RS-14-210

Limerick Generating Station, Units 1 and 2  
Facility Operating License Nos. NPF-39 and NPF-85  
NRC Docket Nos. 50-352 and 50-353

Subject: Third Six-Month Status Report in Response to March 12, 2012 Commission Order  
Modifying Licenses with Regard to Requirements for Mitigation Strategies for Beyond-  
Design-Basis External Events (Order Number EA-12-049)

TITLE: Use of MAAP In Support of FLEX Implementation

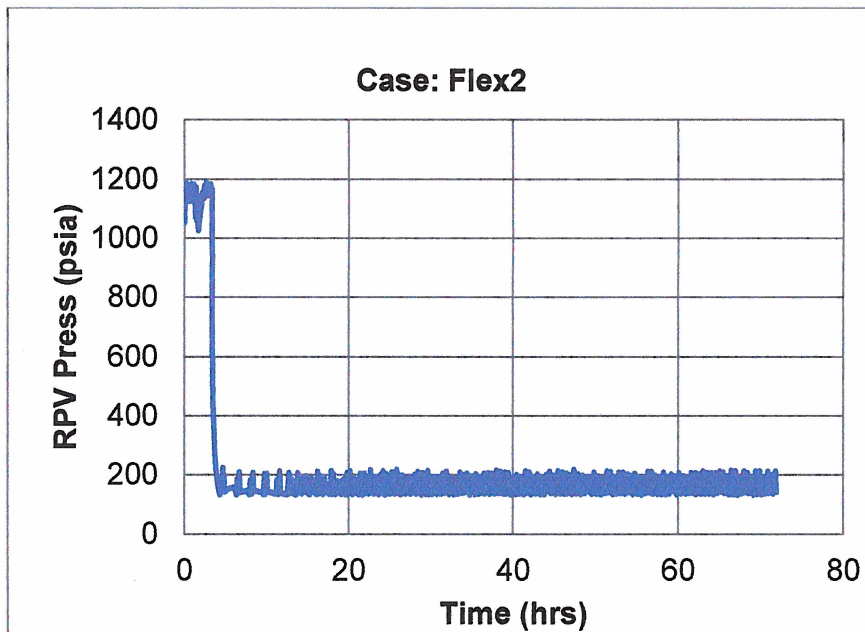
- (2) The collapsed level must remain above Top of Active Fuel (TAF) and the cool down rate must be within technical specification limits.***

Attachment 1A of the Limerick Integrated Plan (Feb 2013) states that the operators would commence a cooldown of the RPV at 20 min per E-1, SBO procedure. A controlled cooldown is identified in the SBO procedures, however, it is authorized to exceed 100 °F/hr if plant conditions require a rapid cooldown. For the MAAP analysis used to simulate the plant response, a single SRV was assumed to be opened to perform the cooldown. The following plot of the RPV pressure from the MAAP analysis confirms this cooldown.

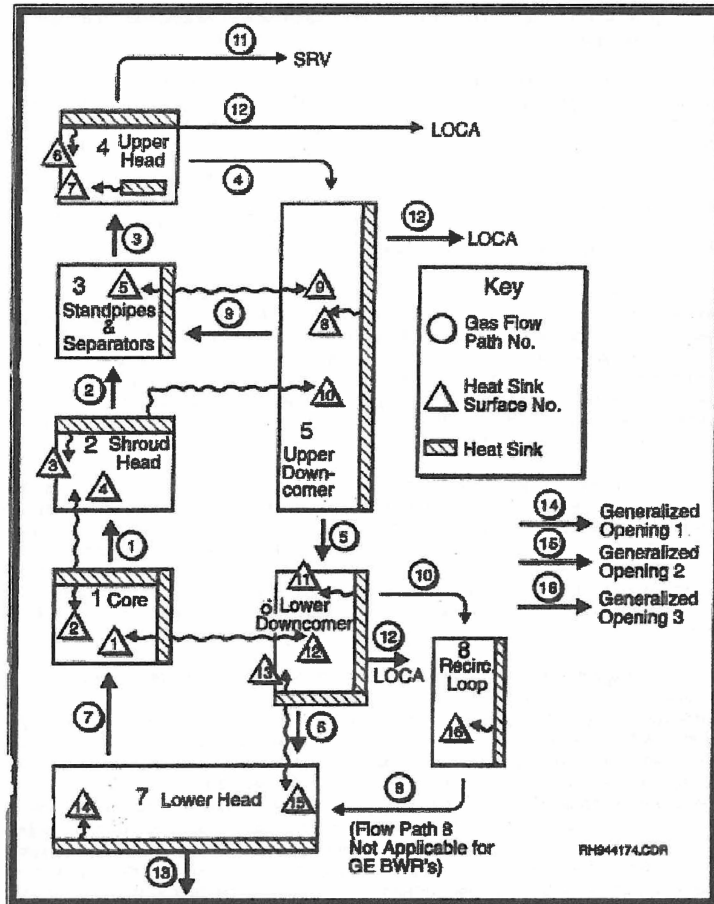
- (4) In using MAAP4, the licensee must identify and justify the subset of key modeling parameters cited from Tables 4-1 through 4-6 of the "MAAP4 Application Guidance, Desktop Reference for Using MAAP4 Software, Revision 2" (Electric Power Research Institute Report 1020236). This should include response at a plant-specific level regarding specific coding options and parameter choices for key models that would be expected to substantially affect the ELAP analysis performed for that licensee's plant. Although some suggested key phenomena are identified below, other parameters considered important in the simulation of the ELAP event by the vendor / licensee should also be included.***

- a. Nodalization***
- b. General two-phase flow modeling***
- c. Modeling of heat transfer and losses***
- d. Choked flow***
- e. Vent line pressure losses***
- f. Decay heat (fission products / actinides / etc.)***

- a. The reactor vessel nodalization is fixed by the MAAP code and cannot be altered by the user, with the exception of the detailed core nodalization. The Limerick MAAP 4.0.6 parameter file divides the core region into 7 equal volume

radial regions and 28 axial regions. The axial nodalization represents 25 equal-sized fueled nodes, 1 unfueled node at the top, and 2 unfueled nodes at the bottom. The figure below, taken from the MAAP User's Manual, illustrates the vessel nodalization scheme.
